ASTOR COLLEGE – S96A NON MATERIAL AMENDMENTS

PROPOSED DESIGN CHANGES: COMMENTARY 12TH FEBRUARY 2019

2.3.3 Louvre vent

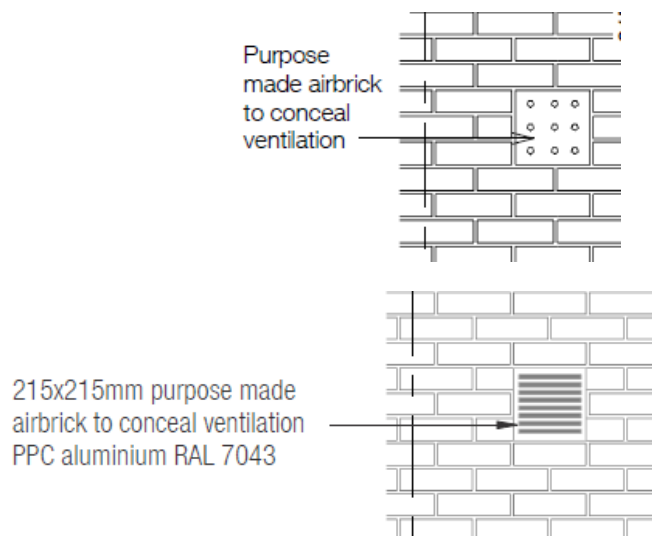
The laundry room has been relocated, and consequently it requires a new ventilation extract system. It is proposed to route the ductwork to exit the building on the rear elevation, via a high-level pane in the new curtain wall system. The louvre will be aluminium and polyester powder coated in colour RAL 7043 to match the curtain wall framing. Drawing extracts above in 2.3.2 also apply. (Refer to drawing 1251.)

2.3.5 Reconfiguration of vent louvres

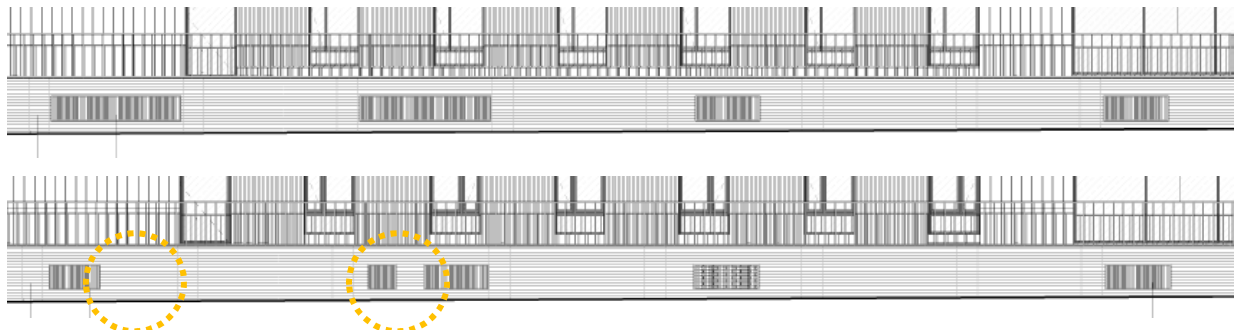
Some areas of ventilation louvres shown on the previously submitted drawing have now been reduced in size. (Refer to drawings 1250.)

2.4.3 Lowered door transom

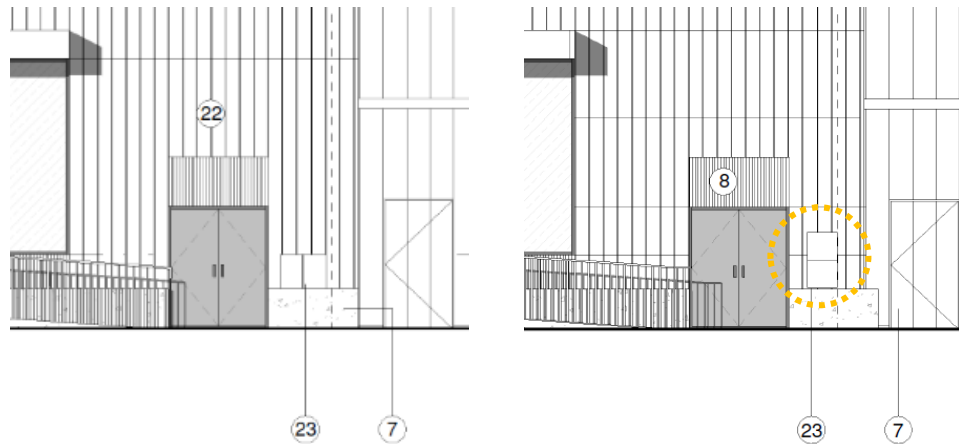
The height of the main entrance door has been reduced in order to reduce its weight and make it easier to operate. The fixed window over has been enlarged to compensate. There is no reduction to the overall amount of glazed façade. (Refer to drawing 1250.)
